DESIGN CHANGES

Project Name	County Flats, Sandfields
Project Ref	OAD_5174
Drawing Ref	1240
Drawing Name	Flat Type F01 Second Floor
Drawn By	WS
Date	21.04.2021

Scale 1:50 Paper Size A3 Rev D

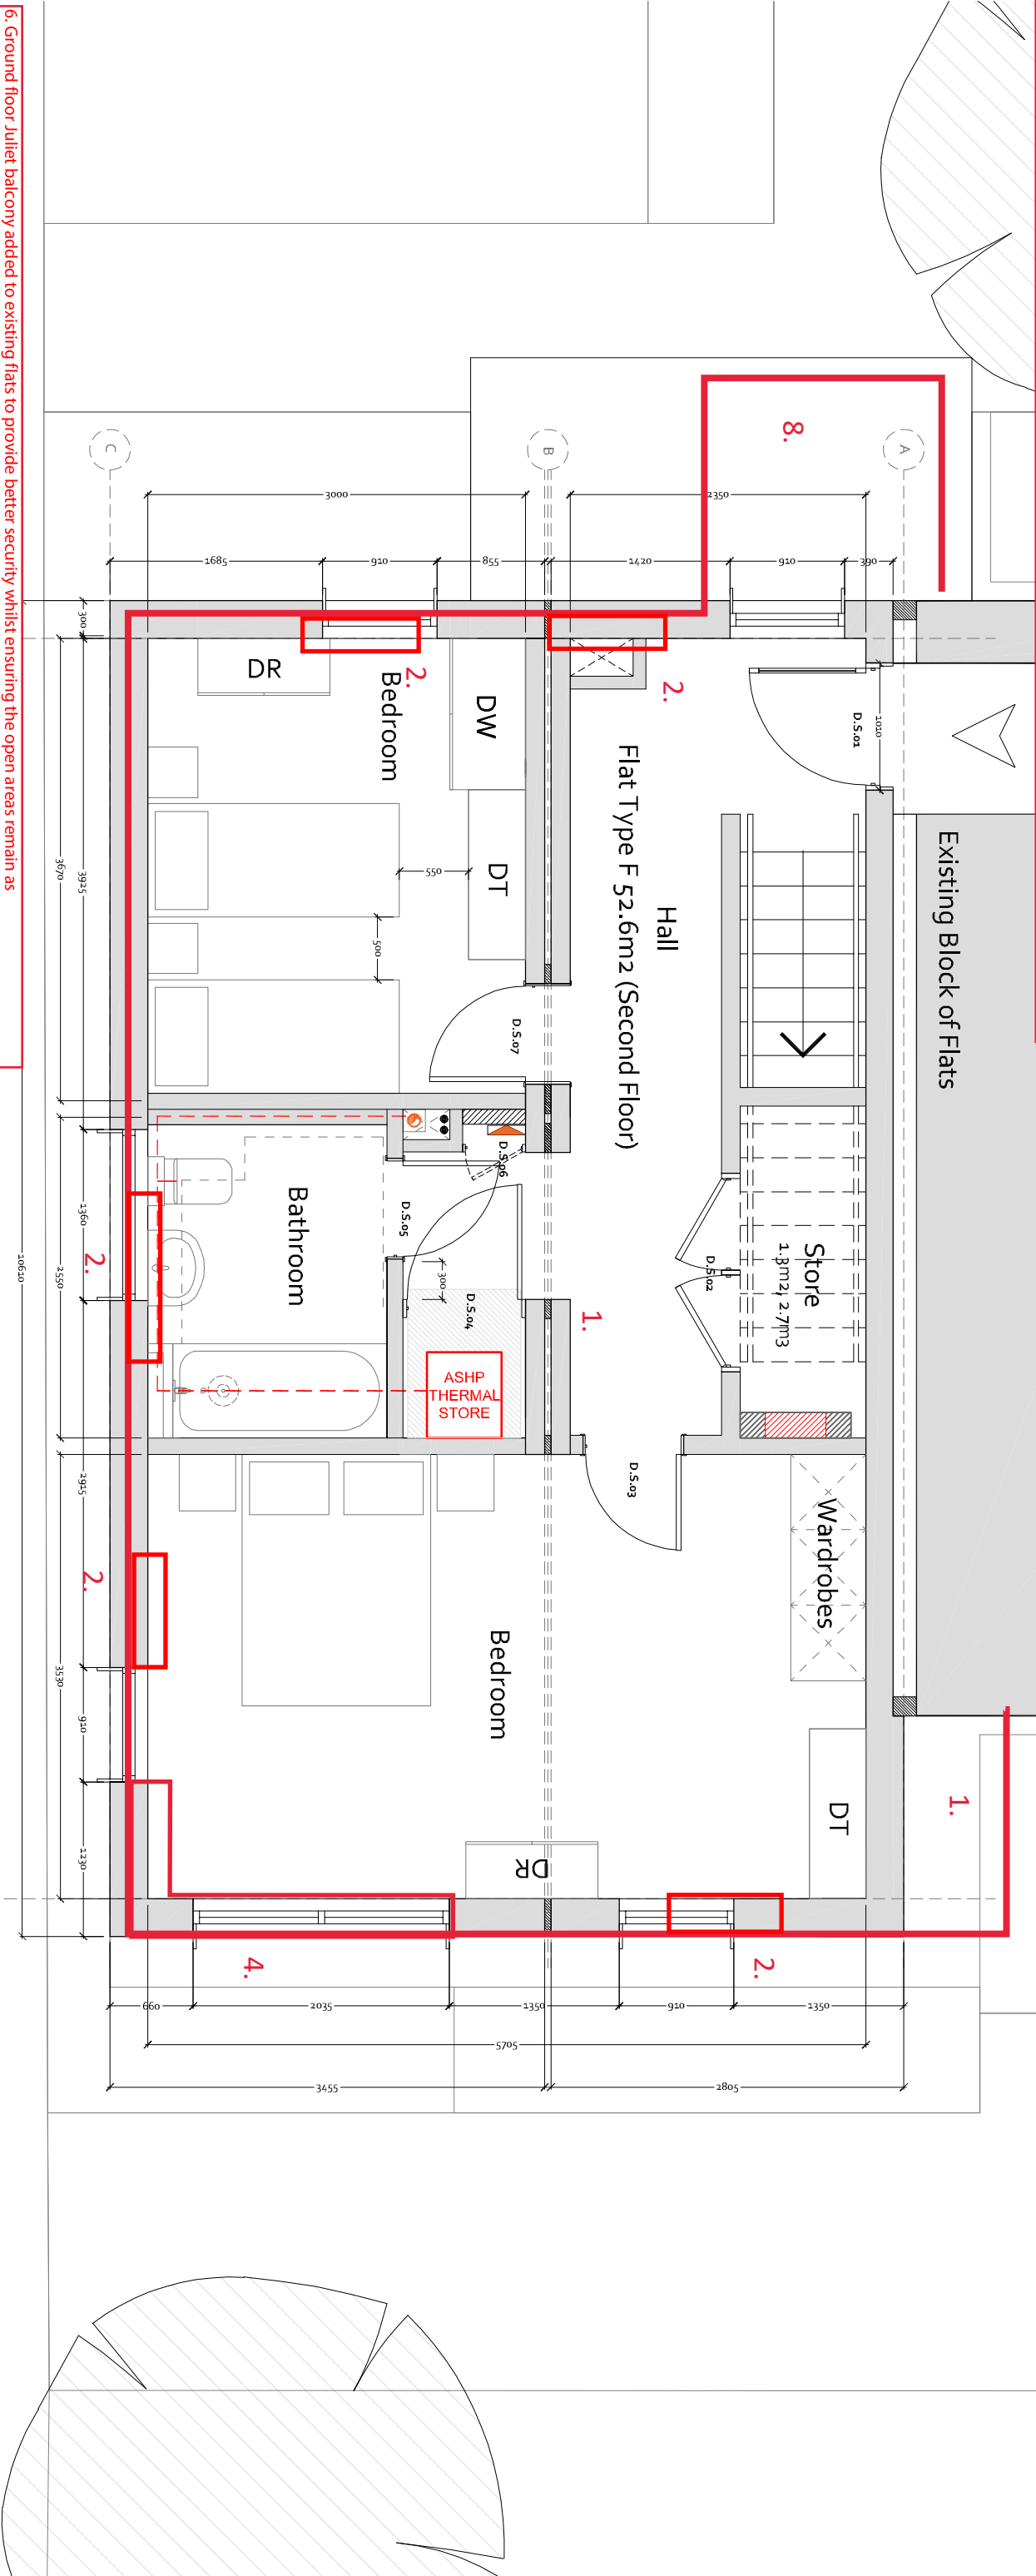
- 1. Modular end links re-positioned slightly off existing buildings, with the party wall straightened and porch projections aligned with this wall, to ensure modular construction can be achieved off site.
- 2. Windows have been slightly re-positioned to the new build to suit the structural design of the modular units and the constraints of the timber frame.
- 3. Parapet to modular end blocks have been lowered by approx 900mm to comply with the structural wind loadings and timber frame design.
- 4. Corner windows have been removed and replaced with 2no. Windows on either corner, again due to the structural and timber frame design of the blocks.
- 5. PV panels have been omitted from the end modular units to suit the structural and timber frame design of the blocks.

- 6. Ground floor Juliet balcony added to existing flats to provide better security whilst ensuring the open areas remain as communal spaces.
- 7. Air source heat pump external louvre enclosure amended to be single storey over entrance canopy to end link blocks.

- 8. External air source louvered enclosure handed to provide internal riser/access requirements for maintenance.
- 9. Buggy/cycle store added to block 6 and 7 parking courtyards.

- 10. Bin stores slightly re-positioned to suit existing drainage runs, with bin store near block 6 amended in size to suit located of bedroom window.
- 11. Footpaths amended to be Tarmac.

- 12. Windows in communal area to the linked blocks made narrower to ensure 1.8m fire separation distance to existing windows is achieved to comply with building regulations.

- 13. 1no. window in block 7 communal area either side of stairwell removed to ensure 1.8m fire separation distance to existing windows is achieved to comply with building regulations.
